File PP-1996-078

Name: Monument Heights Patio Homes – N & W of Franklin / Juniper Streets

**FILE #PP-96-78**

**TITLE HEADING:** Preliminary Plan - Monument Heights  
Patio Homes

PROJECT NARRATIVE FOR MONNUMENT PATIO HOMES SITE PLAN

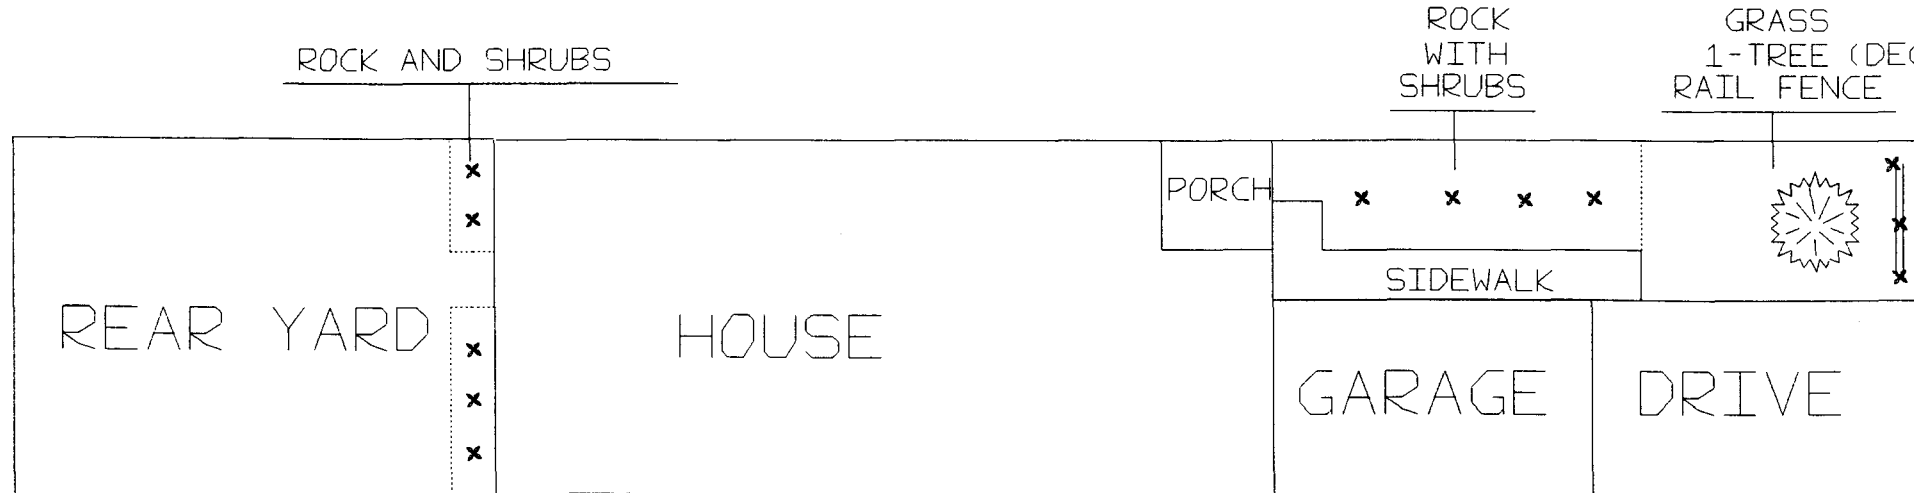
1. All information pertaining to the site plan must be shown on the site plan in ink. Previous submittals showed some site plan information on the plat in pencil.

2. Lots and structures in both developments shall be dimensioned. A typical may be provided for each one.
3. Outer boundary (west & east) of townhomes is mislabeled as 136.55. This is the boundary of the old lot. Correct accordingly. No site boundary for the townhomes is provided.

4. Dimension building footprint (patio homes and townhomes), carports, driveways, sidewalks, setback lines. Show location of exterior doorways.
5. Provide a summary of the land use breakdown for both developments. You need not include the lots not being platted.

6. Change water provider to City of Grand Junction Water
7. Identify proposed utilities including meters and service taps.
8. The site plan is unclear where the 10' utility and drainage easement in lots 1 & 8 begins and ends.

1) A TYPICAL DRAWING, OF THE PATIO HOME, HAS BEEN ADDED.

2) CLARIFICATION OF SETBACKS.

3) NORTH TOWNHOMES DIMENSIONS.

4) EASMENT LINES.

ACCEPTED Bill Nebel  
 ANY CHANGE OF SETBACKS MUST BE  
 APPROVED BY THE CITY PLANNING  
 DEPT. IT IS THE APPLICANT'S  
 RESPONSIBILITY TO PROPERLY  
 LOCATE AND IDENTIFY EASEMENTS  
 AND PROPERTY LINES.

MONUMENT HEIGHTS PATIO HOMES  
 PRELIMINARY PLAN

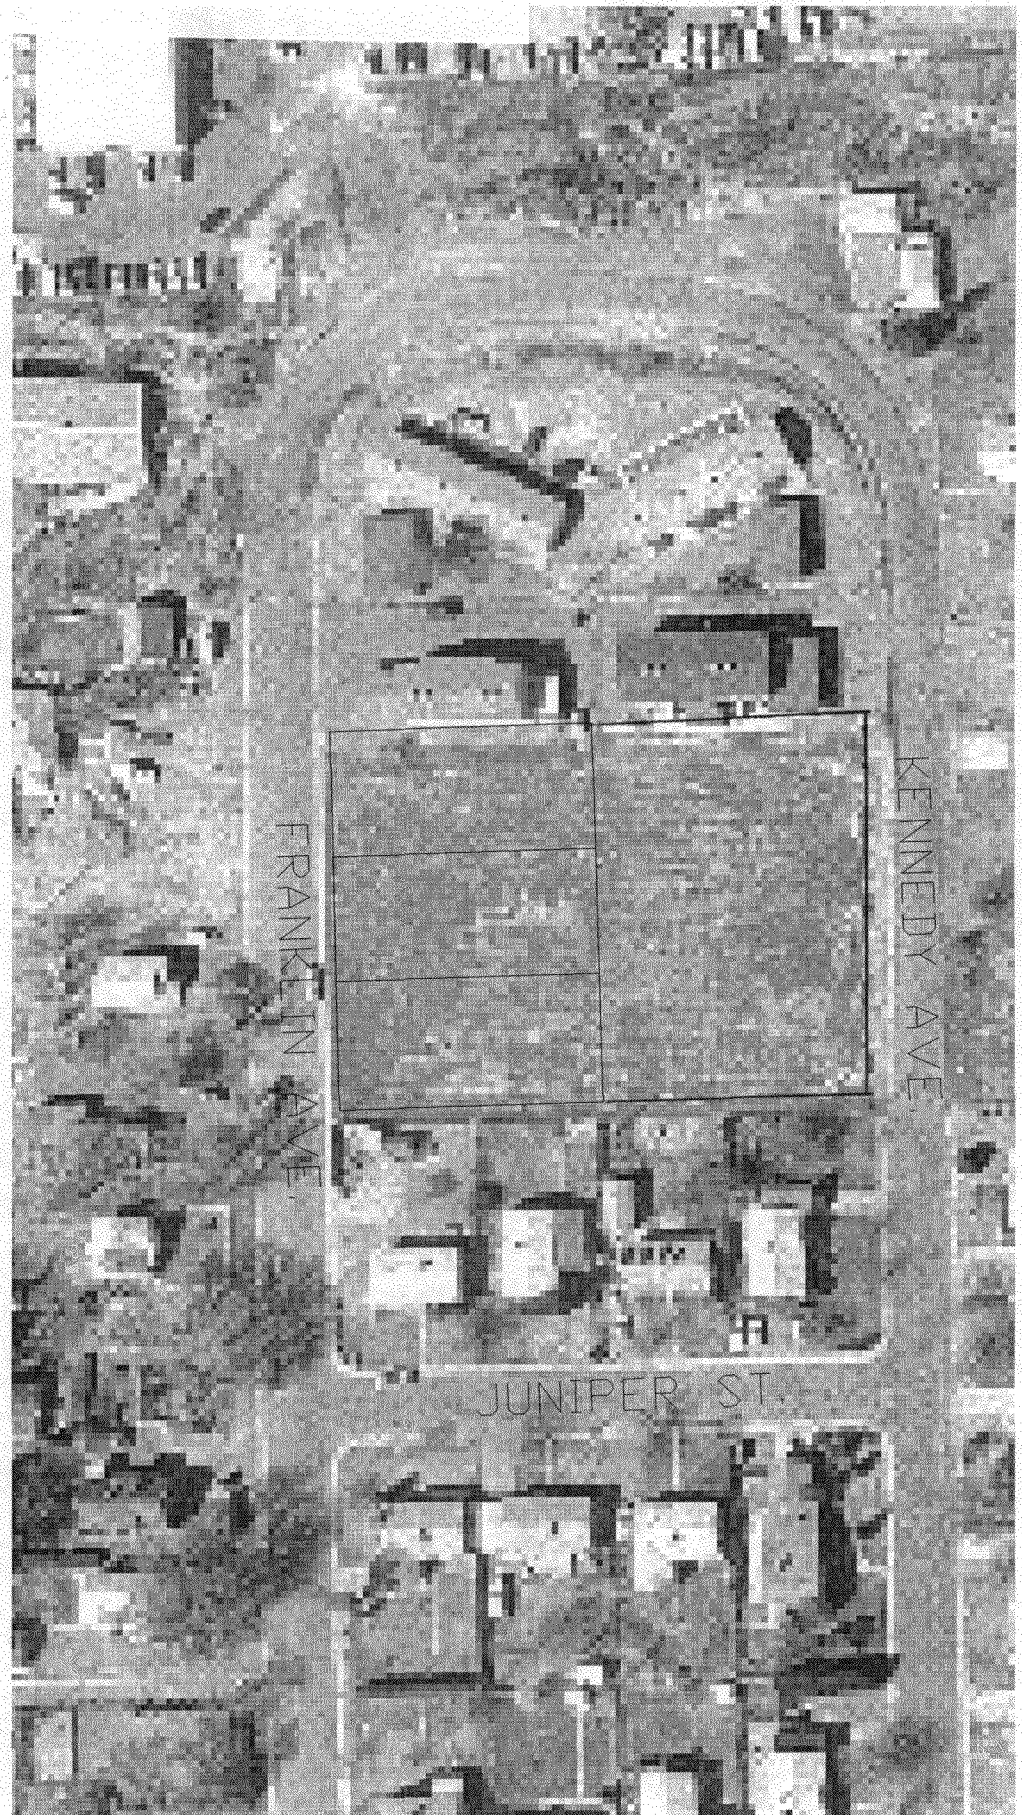
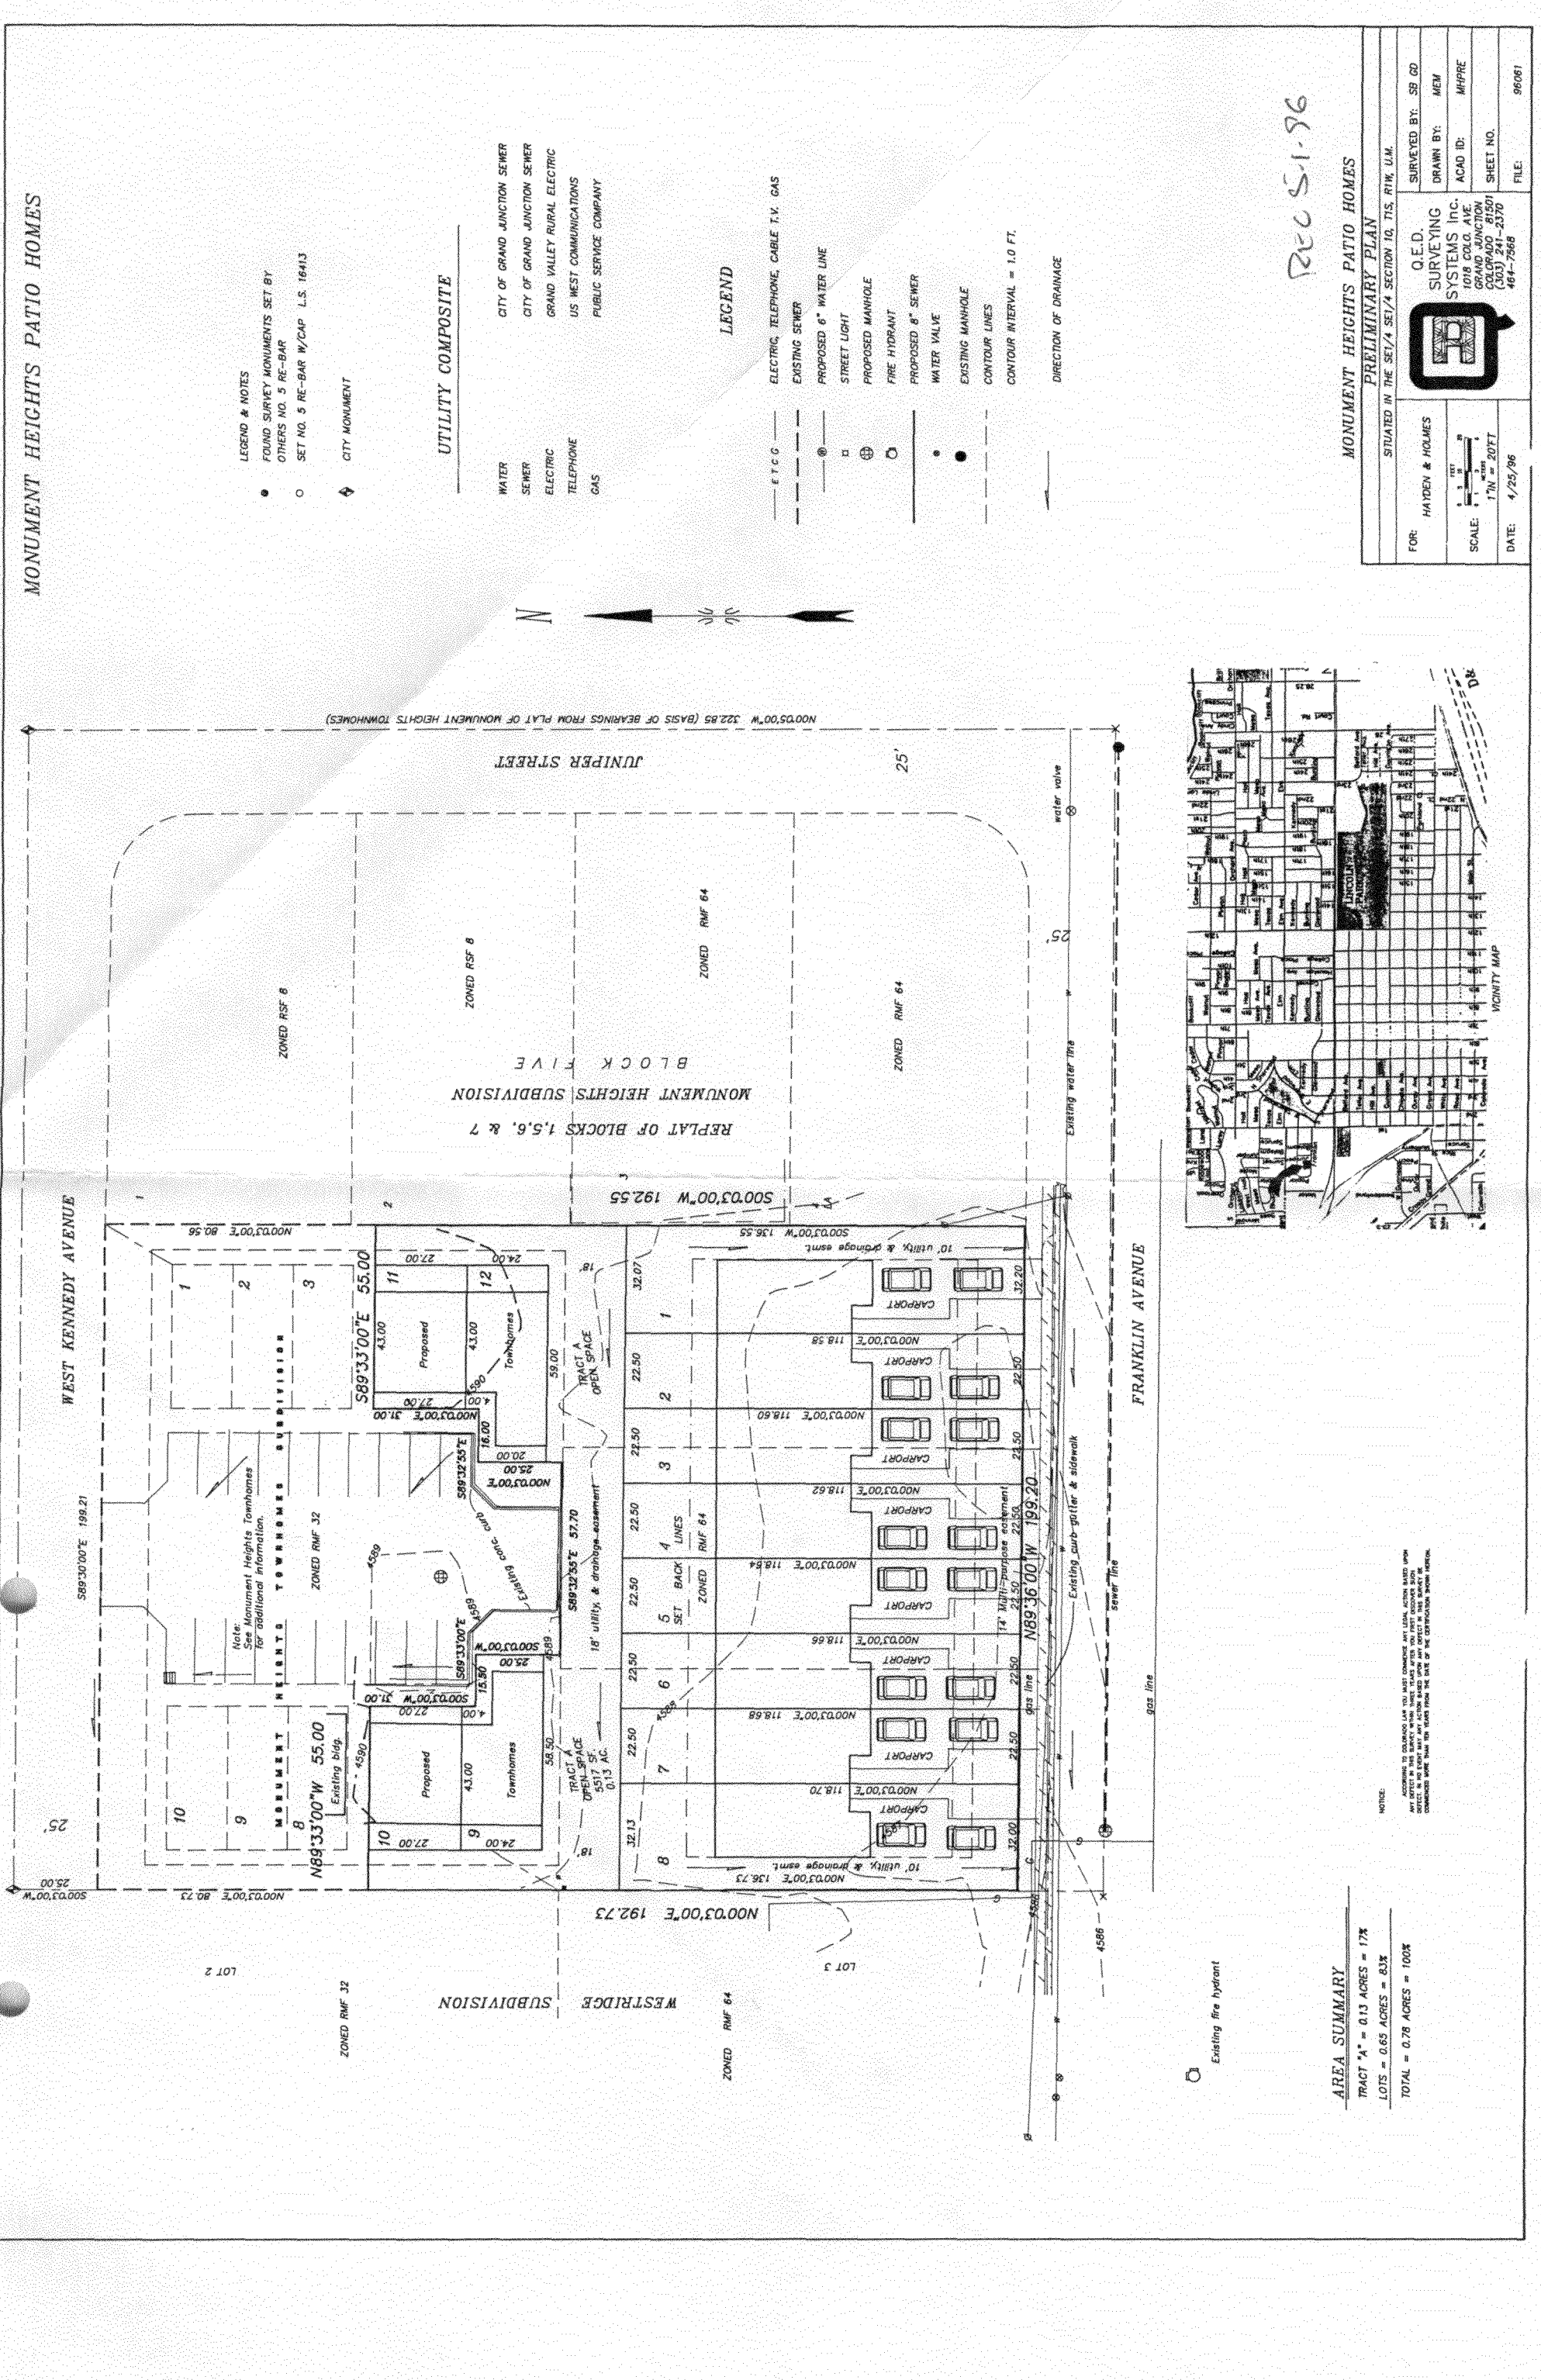
1. The plat map is confusing. It should clearly show the boundaries of Tracts A & B in Monument Heights Townhomes subdivision to the north and the boundaries of all lots being platted or replatted.
2. Is the dashed line around the perimeter of the replatted Monument Heights Townhomes the property line setbacks? They should be shown and labeled as such on the plat and site plan.
3. Preliminary plat does not identify surrounding land use or zoning.

5. Site plan does not provide enough information for the patio homes on lots 1-8. Show adjacent land use and zoning. Show, and identify as such, all paving and concrete walks. show and dimension building footprint, roof line, exterior doorways and roof drain location. Shows any proposed fences or walls. Show right-of-way width from curb to curb or edge of pavement to edge of pavement, right-of-way width and the monument or section line.

6. This site plan is a multi-family project, not a single family project. RMF-64 zoning requires that a minimum of 15% of each lot be landscaped. The site plan must show this landscaping for each lot. The front of each unit shall be fully landscaped (except for walks and driveways) and portions of the rear and/or side yard for at least 15% of each lot. The landscaping will be a requirement of building permit approval. A certificate of occupancy for each unit will not be issued until the required landscaping is in place or has been guaranteed by a development improvements agreement.

7. Show dimensions of garage. A note of curiosity - why are these units so small when there's room for a much bigger dwelling on the site? The units are barely 800 square feet, not counting the garage.

1. Please revise preliminary plan to show that the water purveyor is the City of Grand Junction Water rather than sewer.
2. City of Grand Junction will require one master water meter, rather than 8 individual meters, for this project.

- 1) Tract a shown on preliminary plan where lots 4,5,6 and 7 are being replotted as lots 9, 10, 11, and 12.**
- 2) The dashed lines are not setback lines. see legend on preliminary plan.**

- 3) Land use zoning noted on new preliminary plan.**
- 4) Site plan approval is being requested for the proposed buildings on the lots in replotted Monument Heithts Townhomes. New preliminary plans shows details.**

- 5) Adjacent land use noted on new preliminary plan. Paving, concrete walks, building footprint, exterior doorways and roof drain location shown on lot 1 of patio home lots. Each footprint etc. are the same. No fences or walls are planned. Monument and section lines noted on Preliminary plan.**

- 6) See site and landscape plan.**
- 7) Present lans are for a carport. Demensions are given on the preliminary plan . See lot 1. The square feet of each unit is 964 square feet.**
